Parent Item Name: Fwd Crosstube Support Change

# DART SERVICE INSTRUCTION

TO AMEND INSTALLATION INSTRUCTIONS IIN-D205-594 Rev. C (AND EARLIER) AND INSTRUCTIONS FOR CONTINUED AIRWORTHINESS ICA-D205-594 Rev. 2 (AND EARLIER)  
REF. CANADIAN STC: SH03-6  
REF. FAA STC: SR01742NY

**FIGURE 1: INSTALLATION OF SUPPORT ON CROSSTUBE**

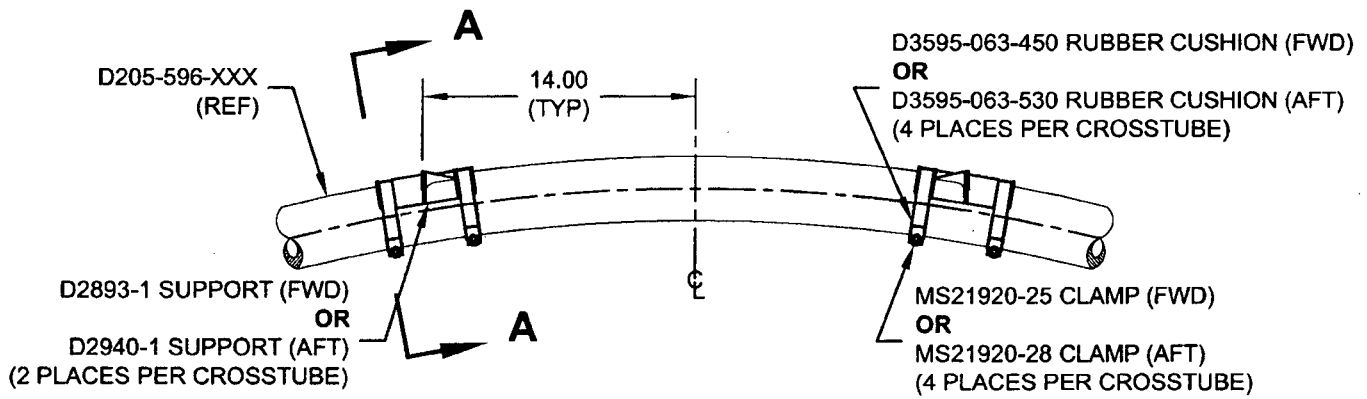
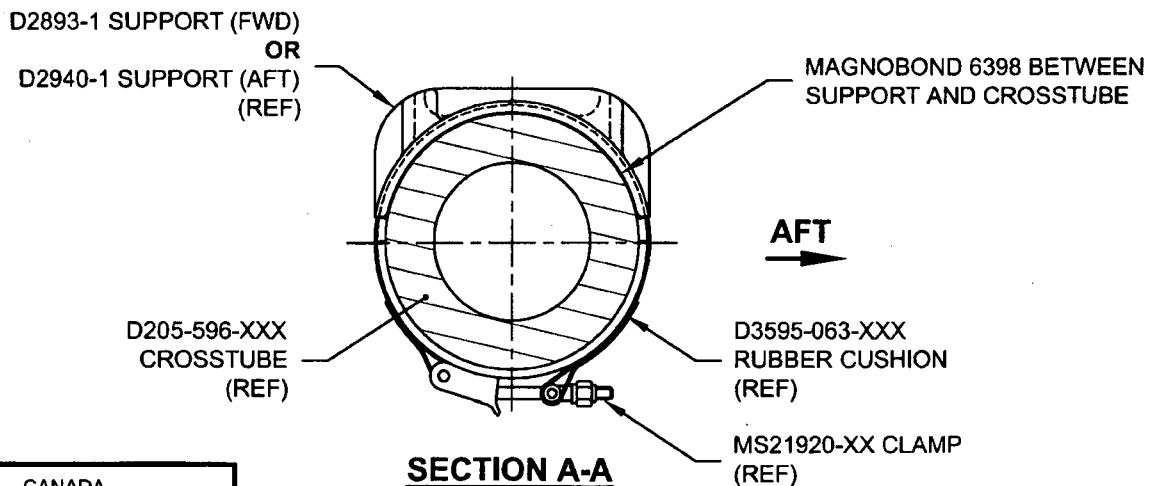
For D205-596-101/-103 Crosstubes (ref. 39" Landing Gear) or D205-596-105/-107 Crosstubes (ref. 31" Landing Gear) at CHG 002 or later, the D2856-600-851/-1009 Abrasion Strips have been removed, the MS21920-25 Clamp replaces the MS21920-24 Clamps, the D2893-1 and D2940-1 Supports have been bonded onto the crosstubes using Magnobond 6398 and D3595-063-450/-530 Rubber Cushions have been installed underneath the MS21920-25/-28 Clamps. Amend Parts List of IIN-D205-594 Section 5 and ICA-D205-594 Section 32.8 as follows:

To prevent the supports from shifting on D205-596-101/-103/-105/-107 Crosstubes at CHG 001, the D2893-1 or D2940-1 Supports should be removed and re-installed as follows:

- 7) Apply a 0.03" to 0.06" thick layer of Magnobond 6398 underneath D2893-1 or D2940-1 Supports and re-install the Supports on the crosstube as shown in Figure 1. Install a D3595-063-450/-530 Rubber Cushion on each MS21920-25/-28 Clamp. Position and secure the D2893-1 or D2940-1 Supports on the crosstube using MS21920-25/-28 Clamps. Torque clamps to 80-100 in-lb. Let the D205-596-101/-103/-105/-107 Crosstube Assembly cure before re-installing the crosstube on the aircraft.

**Note:** It is acceptable to substitute the MS21920-25/-28 with longer or shorter clamps to accommodate varying diameters. Ensure there is a minimum of 1.5 threads in safety on the nut.

QTY -101	QTY -103	QTY -105	QTY -107	Part Number	Description
4		4		D3595-063-450	RUBBER CUSHION
	4		4	D3595-063-530	RUBBER CUSHION
4		4		MS21920-25	CLAMP

B	REPLACE MS21920-24 WITH MS21920-25 ON -101/-105; ADDED EXTRA NOTE TO INSTALLATION PROCEDURE (STEP 7)	MB	07.12.04
A	NEW ISSUE	MB	07.11.16
REV.	DESCRIPTION	BY	DATE
DESIGN	<i>[Signature]</i>	<b>DART AEROSPACE LTD</b>	
DRAWN	<i>[Signature]</i>	HAWKESBURY, ONTARIO, CANADA	
CHECKED	<i>[Signature]</i>	DRAWING NO.	REV. B
MFG. APPR.	<i>[Signature]</i>	DSI 9396	SHEET 1 OF 2
APPROVED	<i>[Signature]</i>	TITLE	SCALE
DE APPR.	<i>[Signature]</i>	CROSSTUBE SUPPORT CHANGE	NTS
DATE	07.12.04	COPYRIGHT © 2007 BY DART AEROSPACE LTD THIS DOCUMENT IS PRIVATE AND CONFIDENTIAL AND IS SUPPLIED ON THE EXPRESS CONDITION THAT IT IS NOT TO BE USED FOR ANY PURPOSE OR COPIED OR COMMUNICATED TO ANY OTHER PERSON WITHOUT WRITTEN PERMISSION FROM DART AEROSPACE LTD.
